## Permit Issuance Information

<b>Application No</b>	TRE-APP-APP25-38802121
<b>Permit No</b>	TRE-PMT-26-38902121
<b>Site Address</b>	
<b>Type of Record</b>	Building/Permits/Tree Permit/Permit
<b>Date Issued</b>	01/23/2026
<b>Record Status</b>	Active
<b>Primary Applicant</b>	Becky Carrol, Pape-Dawson Engineers, PAPE-DAWSON ENGINEERS, INC.
<b>Scope of Work</b>	Guajolote Ranch-Phase 2 Tree Plan Single-Family Residential
<b>Approval Comments</b>	
Completeness Review	Comments Tree permit application submittal documents complete.

\*\*\*OVERALL APPROVED TREE PRESERVATION PLAN FOR GUAJOLOTE RANCH PHASE 2 UNITS 4, 5, 6, 7, 8, 9, 10, 13, 14, 16, 17, 19, 20, 22, 23, 24, 26, 27, 28 & COLLECTOR ROAD PHASE 4\*\*\*\*\*

**GUAJOLOTE RANCH-PHASE 2 TREE PLAN**  
 BEXAR COUNTY, TEXAS  
 OVERALL TREE PRESERVATION PLAN

PLAT NO.	12356-16
JOB NO.	12356-16
DATE	JANUARY 2026
DESIGNER	SS
CHECKED	DRAWN ZP
SHEET	T1.00

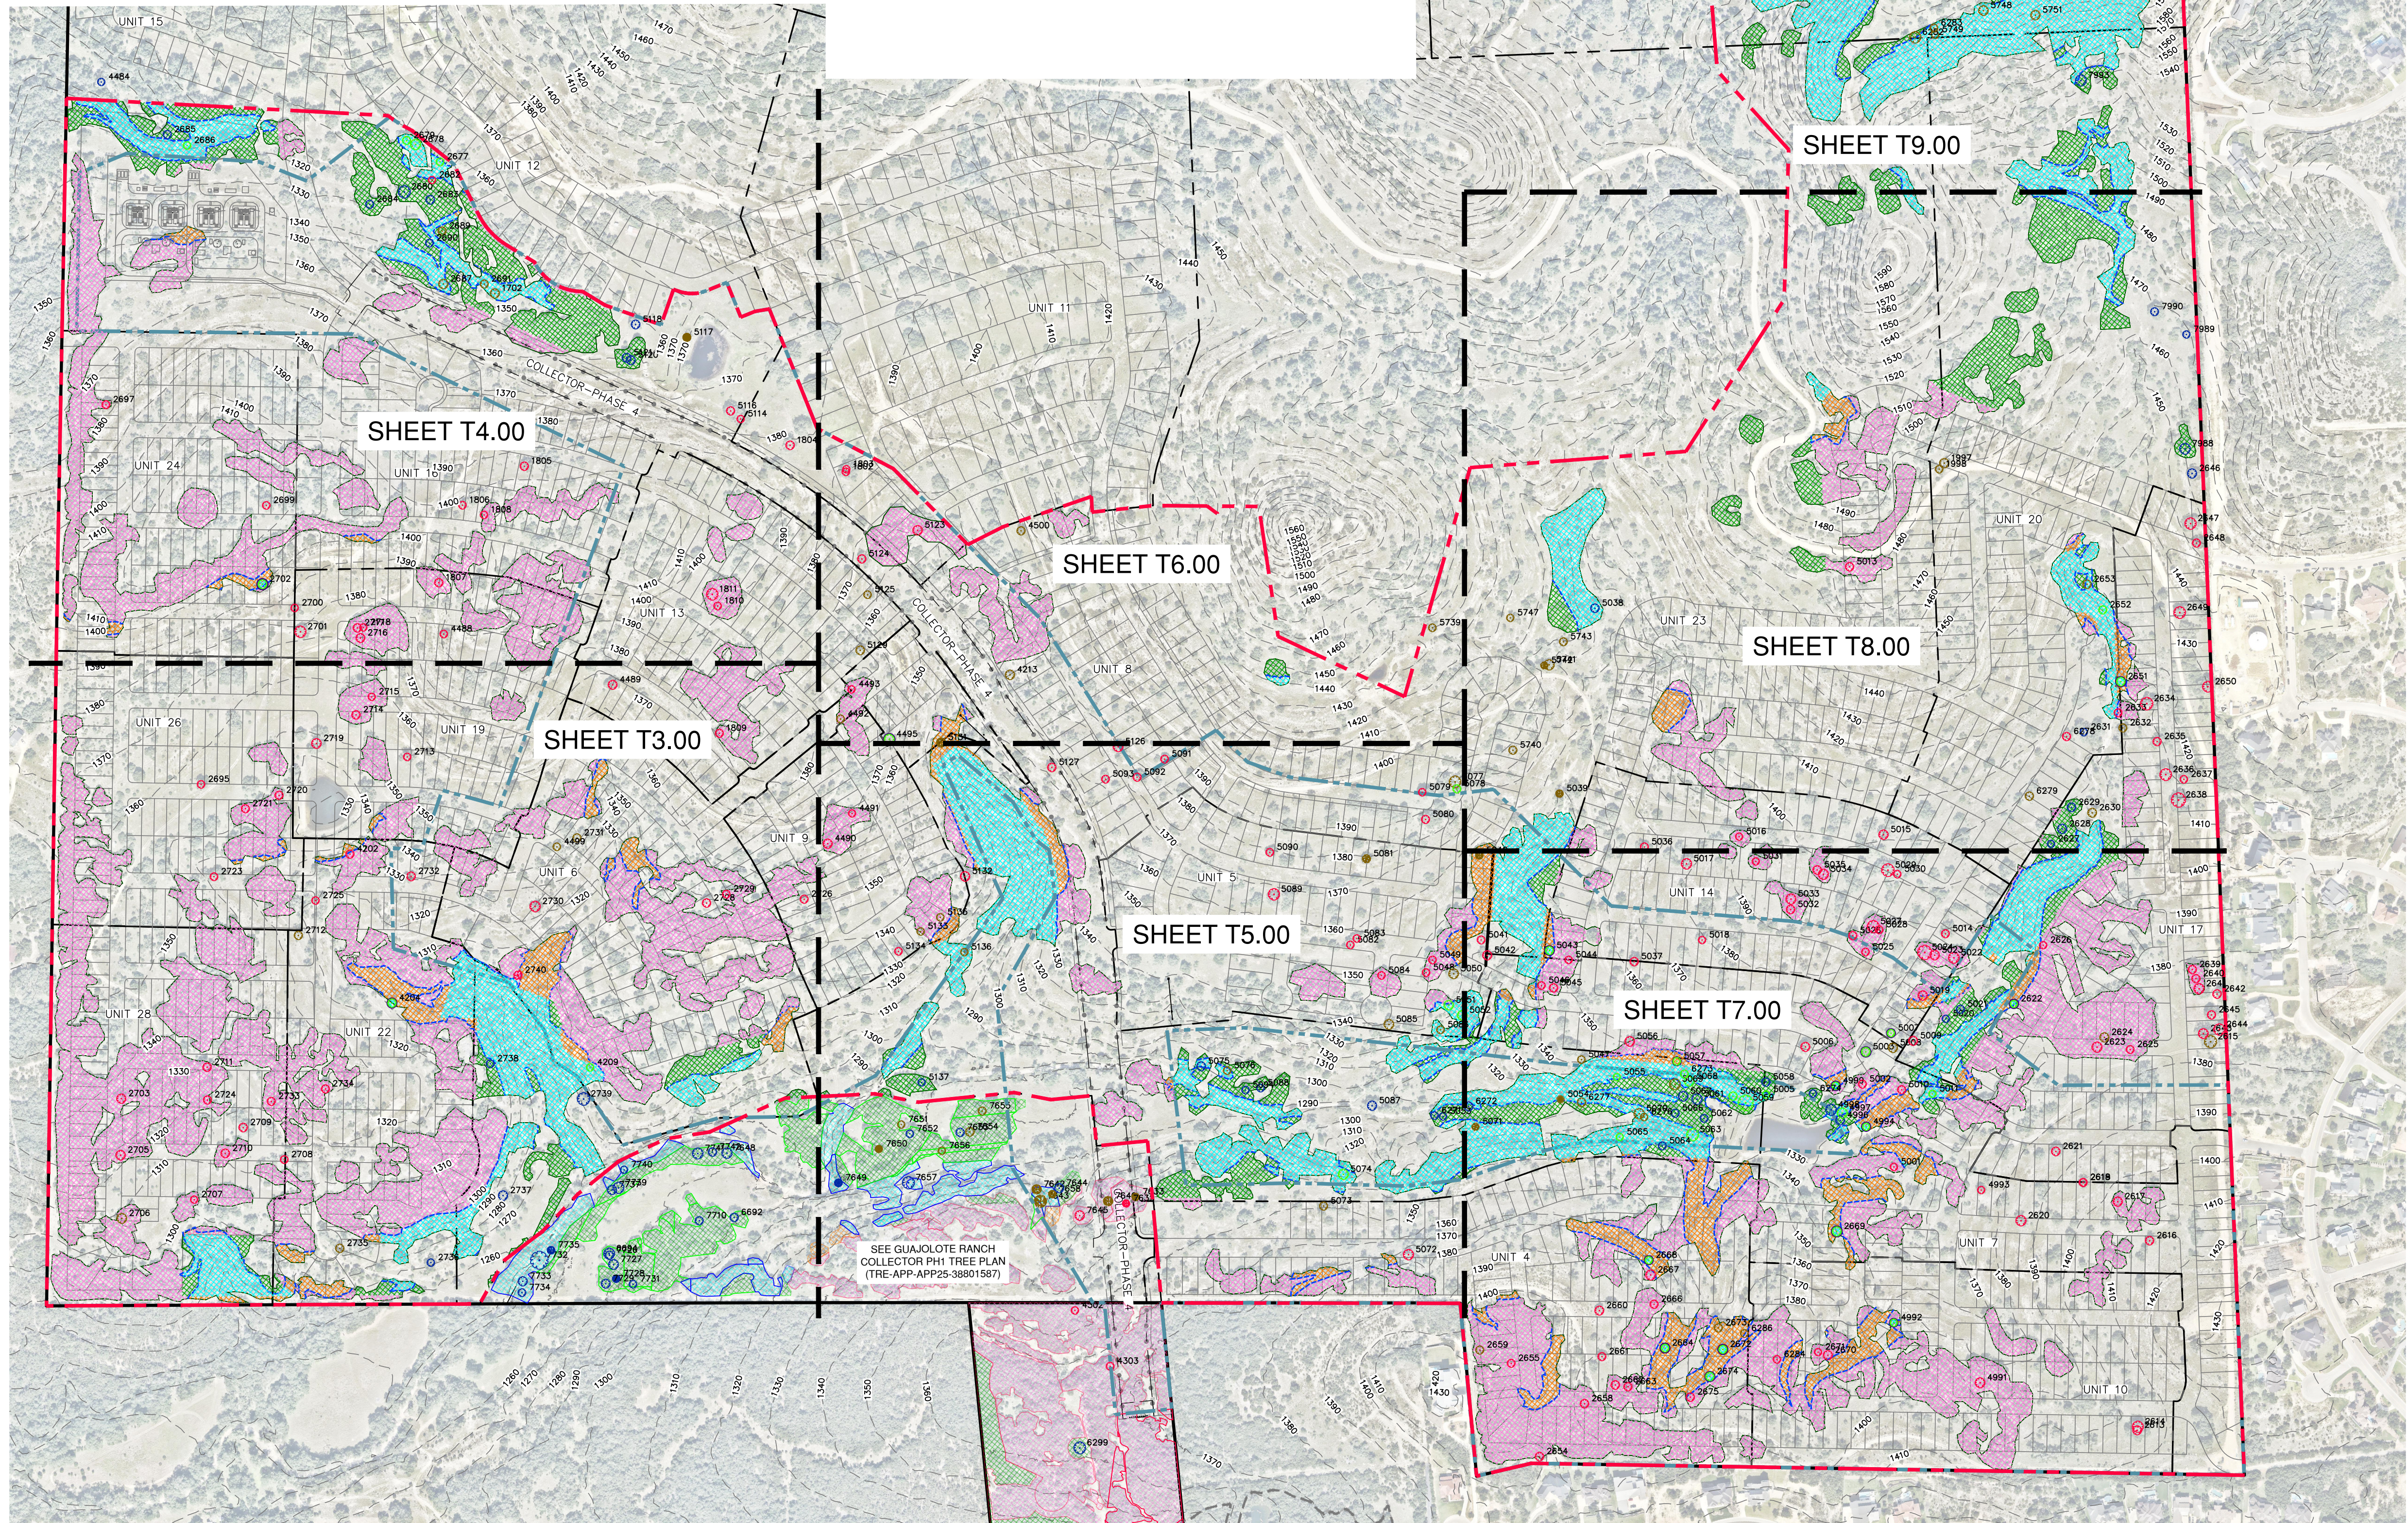
// STATUS: APPROVED 1.23.26(UNITS 4, 5, 6, 7, 9, 10, 13, DETENTION BASINS, WASTEWATER TREATMENT PLANT, & COLLECTOR ROAD PHASE 4 ONLY - 2023 TREE STAND DELINEATION METHOD)

-(4)-1.5" CALIPER NATIVE MEDIUM TO LARGE SHADE TREES REQUIRED PER LOT AT BUILDING STAGE FOR UDC, MITIGATION, AND TREE CANOPY COVER REQUIREMENTS.

-(194)-1.5" CALIPER NATIVE MEDIUM TO LARGE STREETScape TREES REQUIRED ALONG COLLECTOR ROAD PHASE 4. A STREETScape BOND SHALL BE REQUIRED AT THE PLATTING STAGE FOR THE PORTION OF COLLECTOR ROAD PHASE 4 BEING PLATTED.

-FULL COMMERCIAL FEES SHALL APPLY FOR THE WASTEWATER TREATMENT PLANT AT TIME OF

PLATTING.  
-THIS SUBDIVISION IS SUBJECT TO A MASTER TREE PLAN (TRE-APP-APP25-38802121) WHICH REQUIRES COMPLIANCE BY THE OWNERS OF ALL PROPERTY WITHIN THE PLAT BOUNDARY, AND THEIR EMPLOYEES AND CONTRACTORS, AND SHALL BE BINDING ON ALL SUCCESSORS IN TITLE EXCEPT FOR OWNERS OF SINGLE-FAMILY RESIDENTIAL LOTS SUBDIVIDED HEREUNDER FOR WHICH CONSTRUCTION OF A RESIDENTIAL STRUCTURE HAS BEEN COMPLETED. THE MASTER TREE PLAN IS ON FILE AT THE CITY OF SAN ANTONIO ARBORISTS OFFICE. NO TREES OR UNDERSTORY SHALL BE REMOVED WITHOUT PRIOR APPROVAL OF THE CITY ARBORIST OFFICE PER 35-477(H).  
-CONSTRUCTION ON INDIVIDUAL RESIDENTIAL LOTS OUTSIDE OF CITY LIMITS ARE REQUIRED TO SUBMIT A TREE PERMIT APPLICATION REFERENCING APPROVED TREE PRESERVATION PLAN TO VERIFY COMPLIANCE AT BUILDING STAGE. FAILURE TO DO SO COULD INCUR CESSATION OF ON-SITE CONSTRUCTION, ADDITIONAL MITIGATION, AND/OR WORK WITHOUT PERMIT PENALTIES.
